UNITED STATES PATENT AND TRADEMARK OFFICE

APPLICATION NO.	FILING DATE	FIRST NAMED INVENTOR	ATTORNEY DOCKET NO.	CONFIRMATION NO.
10/529,562	03/28/2005	Won-Seok Kang	22104.29047	9148
26781	7590	05/30/2008		
BROUSE MCDOWELL LPA 388 SOUTH MAIN STREET SUITE 500 AKRON, OH 44311			EXAMINER CECIL, TERRY K	
			ART UNIT 1797	PAPER NUMBER
			NOTIFICATION DATE 05/30/2008	DELIVERY MODE ELECTRONIC

Office Action Summary	Application No. 10/529,562	Applicant(s) KANG ET AL.	
	Examiner Mr. Terry K. Cecil	Art Unit 1797

DETAILED ACTION

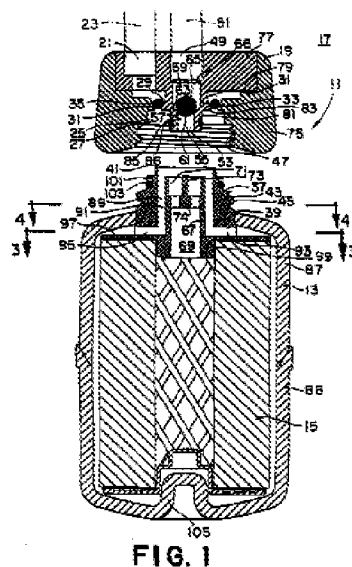
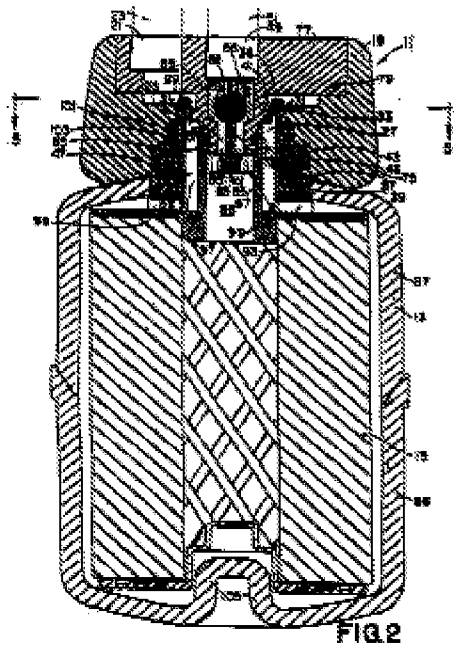
As can be readily seen in figures 1 and 2 produced above, Williams teaches the limitations of the aforementioned claims including each of the inlet and outlet ports of the connector including a ball valve body that is opened

by a respective pusher of the filter [as in claim 1]. Williams doesn't teach the connector being swingable about a pivot axis between a filter service position and a filter replacement position.

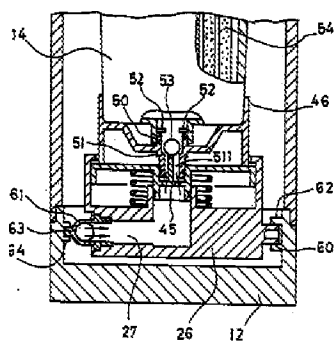
But such is taught by Higashijima.

Higashijima teaches a connector 65 that pivots to a service position [as in claim 1]. It is considered that it would have been obvious

to one ordinarily skilled in the art at the time of the invention to have the connector of Williams to be pivotable as in Higashijima since such would make filter replacement easier.

FIG. 4a

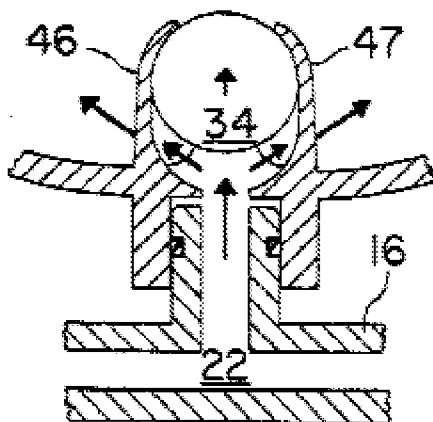
Stankowski teaches grooves (between the arms 46, 47) on the inner circumference of a valve chamber.

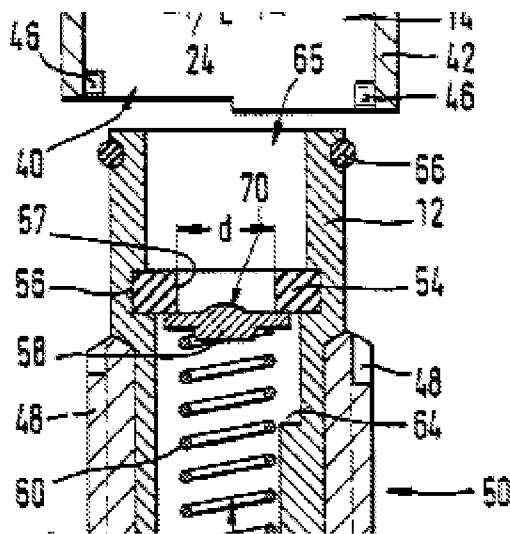
In the figure, the grooves are shown traversed by the flow arrows [as in claim 1]. It is considered that it would have been obvious to the skilled man to have the groove of Stankowski in the valve chambers of the modified Williams, since Stankowski teaches the benefit of allowing flow through the passage while

retaining the valve ball therein. As for claim 3, the valve of Williams is a ball closed by the pressure of the incoming raw water. As for claim 4, Stankowski teaches a poppet valve (figure 2) including a projecting rod 30 contactable with a pusher 29. It is considered that it would have been obvious to one ordinarily skilled in the art at the time of the invention to have the poppet valve of Stankowski as the ball valve of Williams, since such is merely simple substitution of a prior art element for performing the same function (stopping flow when a filter is removed).
